**SUBJECT: NEW VEHICLE DEMONSTRATION / DELIVERY HOLD -
Safety Recall 22S09 – Supplement #1**

Certain 2017 - 2022 Model Year F-250/F-350 Vehicles Equipped with a 6.2L/7.3L Gas Engine, Crew Cab/Super Cab, 160"/164" Wheelbase, 4x4, and One-Piece Aluminum Driveshaft
Loose/Sagging Underbody Insulator

New! REASON FOR THIS SUPPLEMENT

FIGURE 7

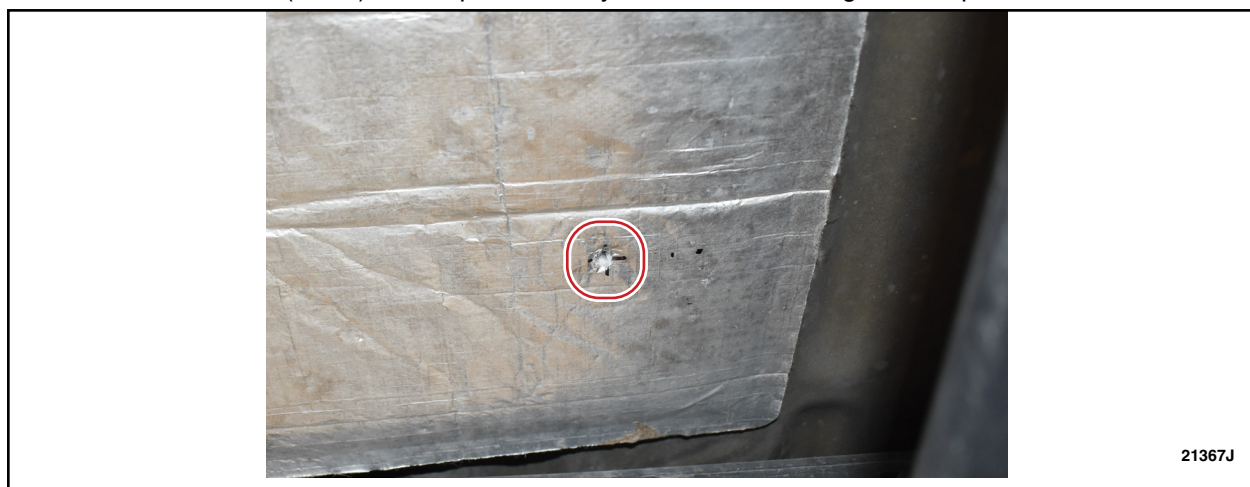
- *Additional part numbers for rivets are now available as part of the seed stock program.*
- *Rivets may be used for both 21S56 and/or 22S09.*
- *Certain rivet part numbers may use different drill bit sizes.*

7. Use the 5.1 mm (13/64 in) drill bit for rivet part number W719880-S417 or the 6.7mm (17/64 in) drill bit for all other rivet part numbers to drill a hole through the insulator and into the floor. See Figure 7.
